GENERAL ELECTRIC COMPANY, 175 CURTNER AVE., SAN JOSE, CALIFORNIA 95125
MC 682 (408) 925-5040

MFN 053-83
JNF 015-83

SUBJECT: IN THE MATTER OF 238 NUCLEAR ISLAND
GENERAL ELECTRIC STANDARD SAFETY ANALYSIS REPORT (GESSAR II)
DOCKET NO. STN 50-447

REVISED DRAFT RESPONSES

Figure 8.3-1. Nuclear Island
Single Line AC & DC
Aux Power System

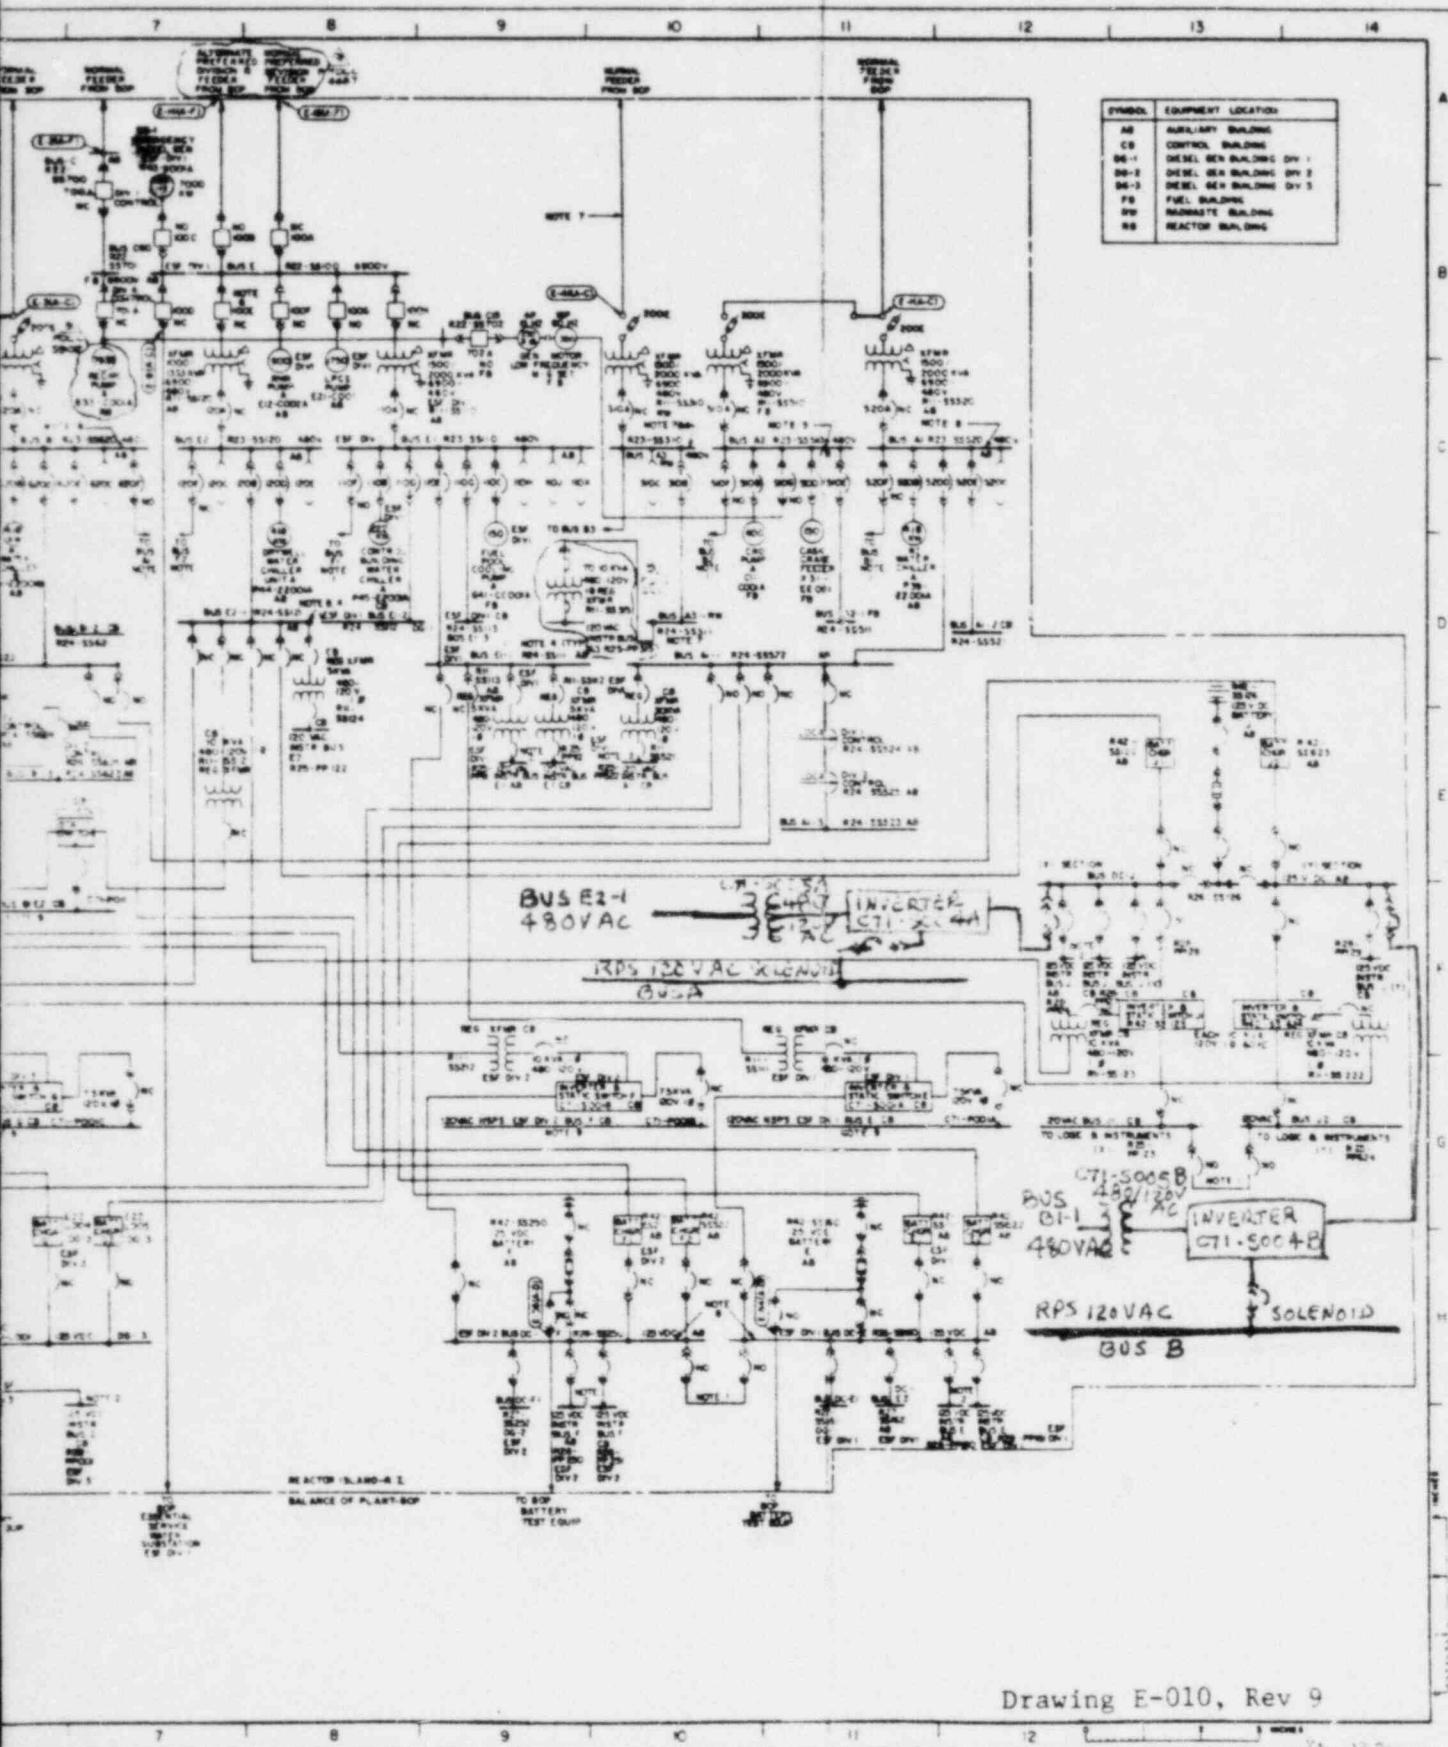
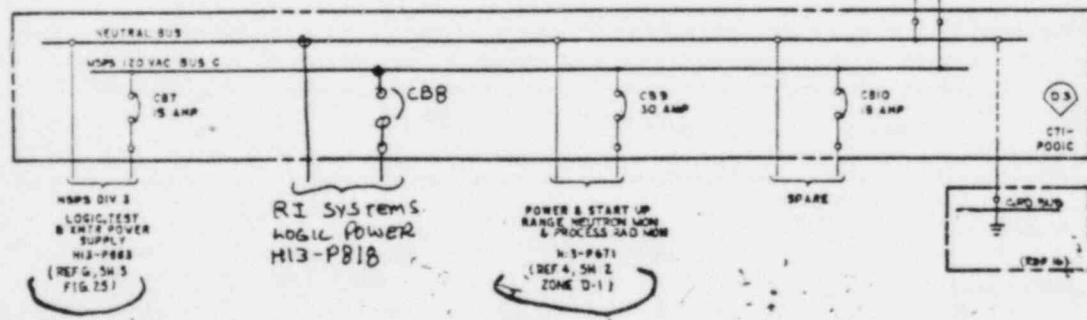
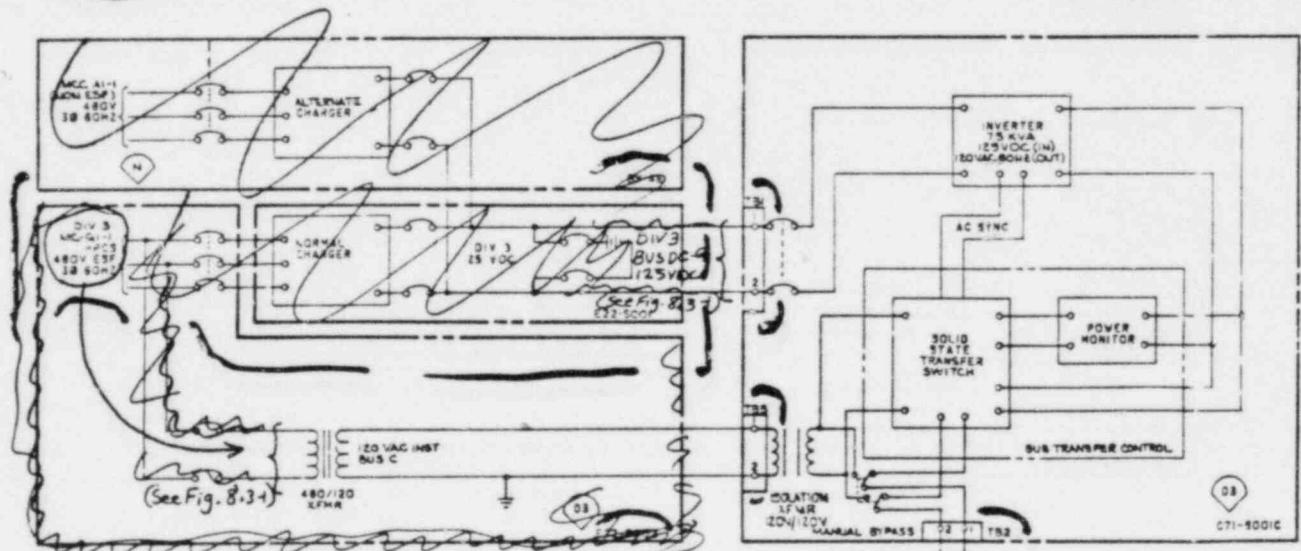
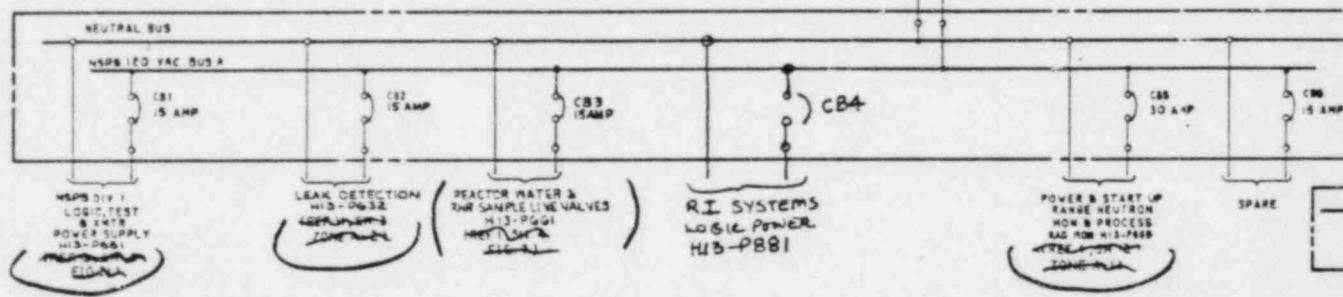
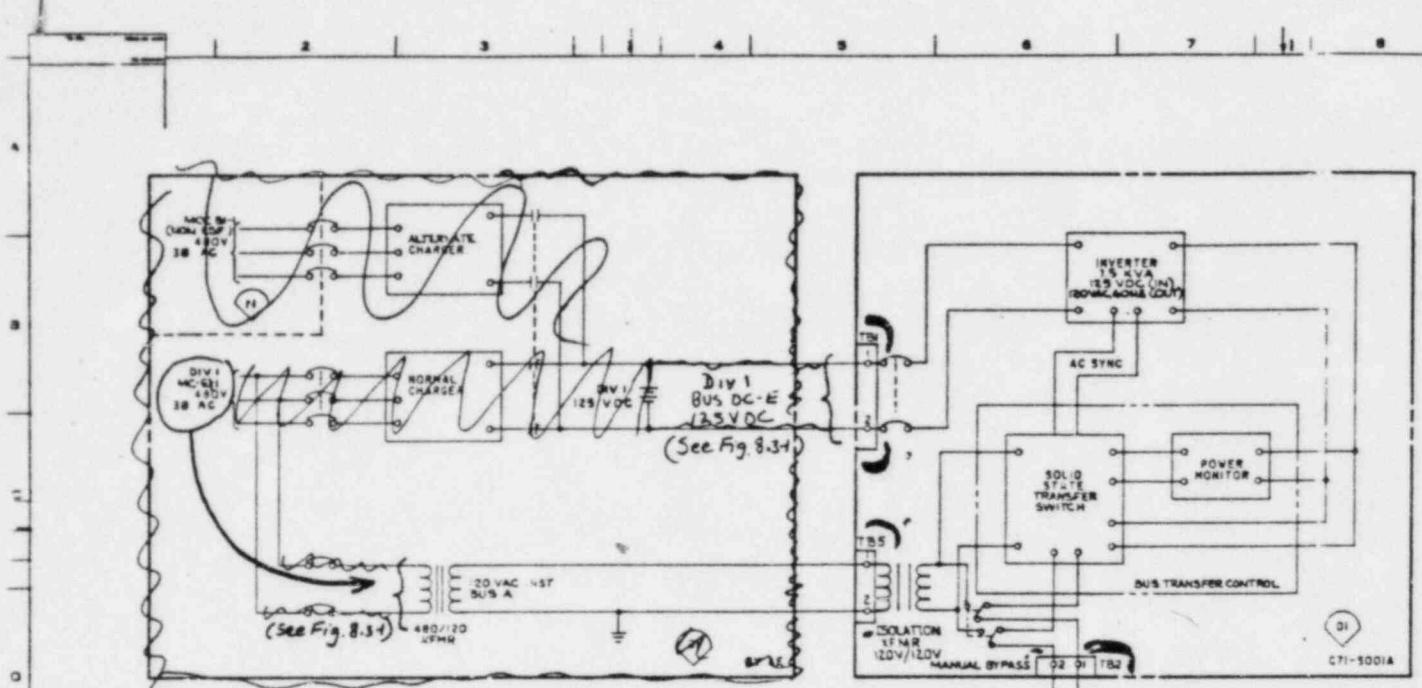
* Note: Figure 8.3-1 will be modified to match the "new" Figures 8.3-20a through 8.3-20d.

UPDATE FIG. 8.3-1 AS MARKED

E&I IDENT: NSPS	12 POWER DISTRIB	GENERAL ELECTRIC	8235545
NUCLEAR SAFETY RELATED		ELEM DIAG	
VOLUME PROTECT	NAME	NSPS POWER DISTRIBUTION	
NUCLEAR SAFETY RELATED		NUCLEAR STANDARD PLANT ENSUREGDI

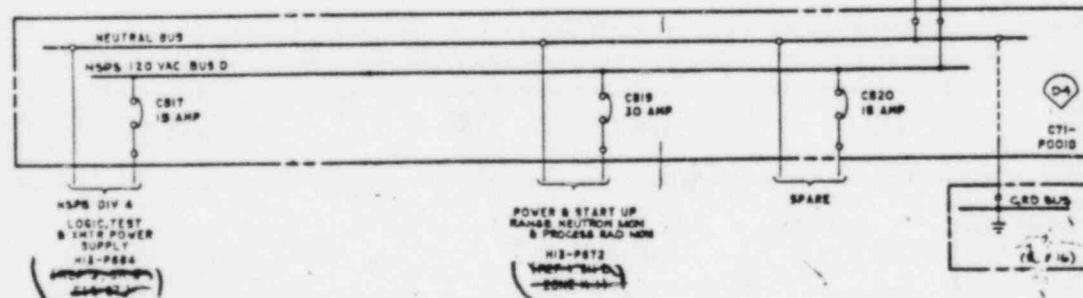
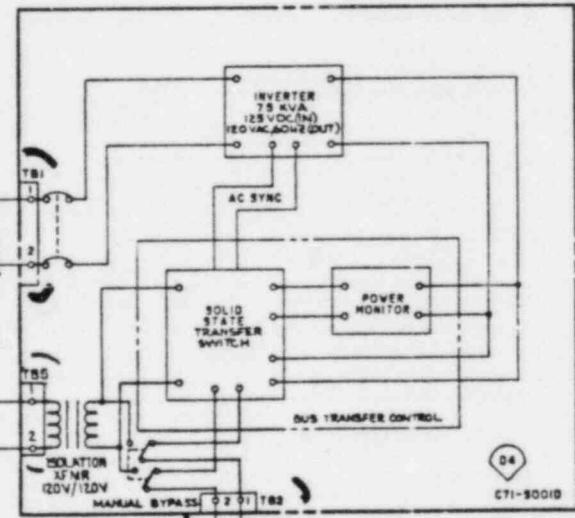
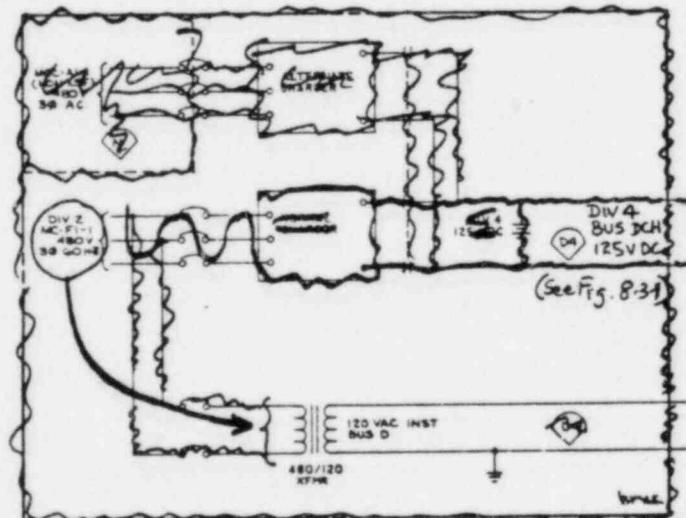
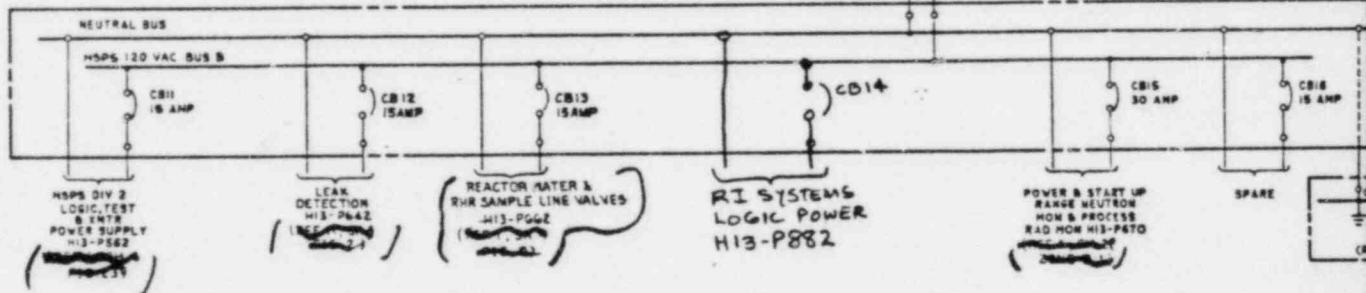
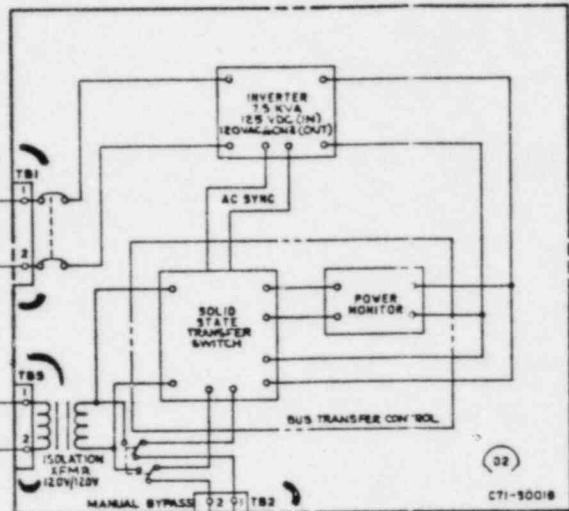
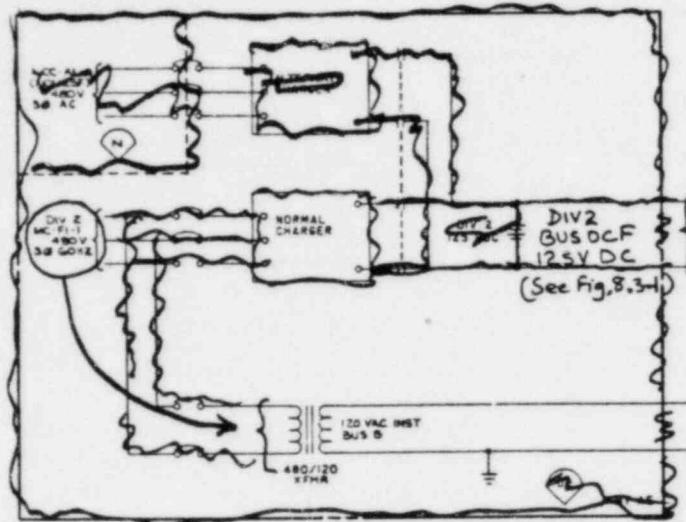
UPDATE GESEAR II FIG. 8.3-20a AS PER THIS DWG.

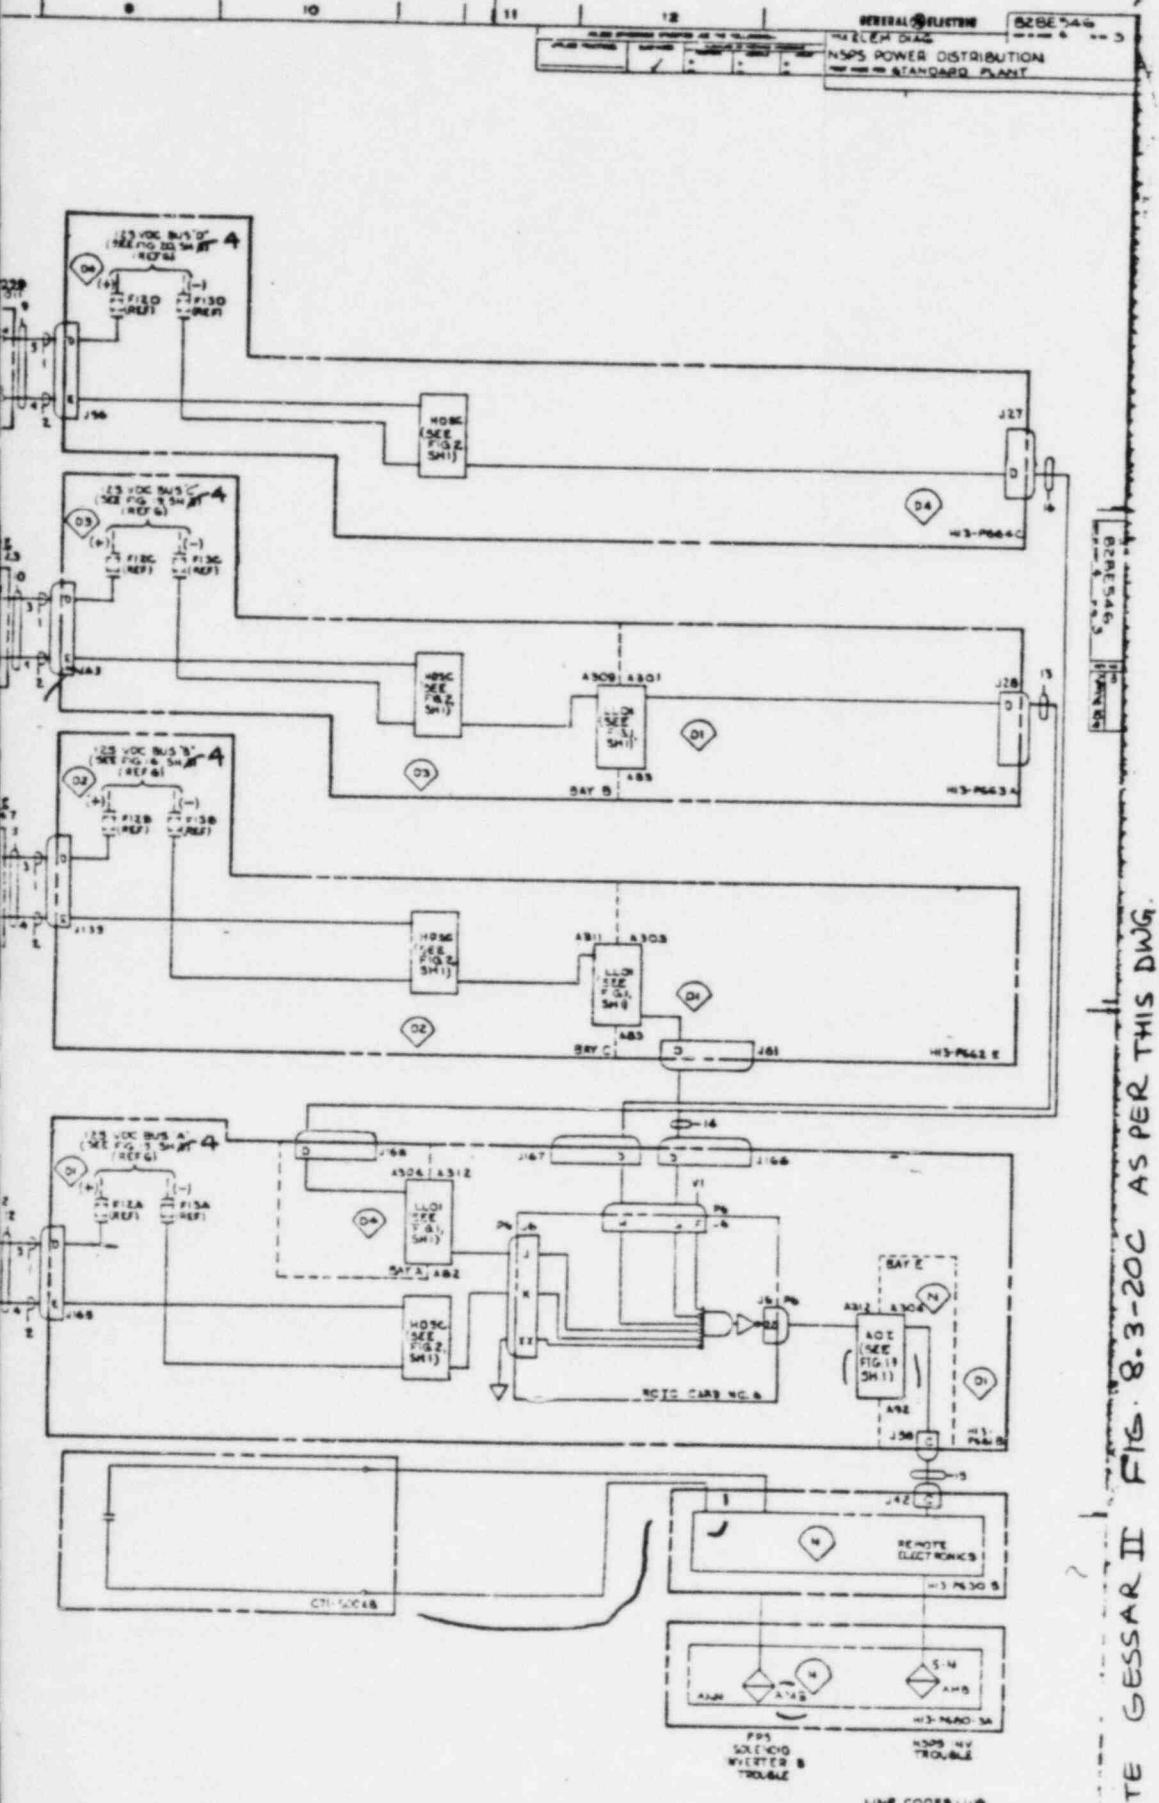
UPDATE GESSAR II FIG. 8.3-306 AS PER THIS Dwg.
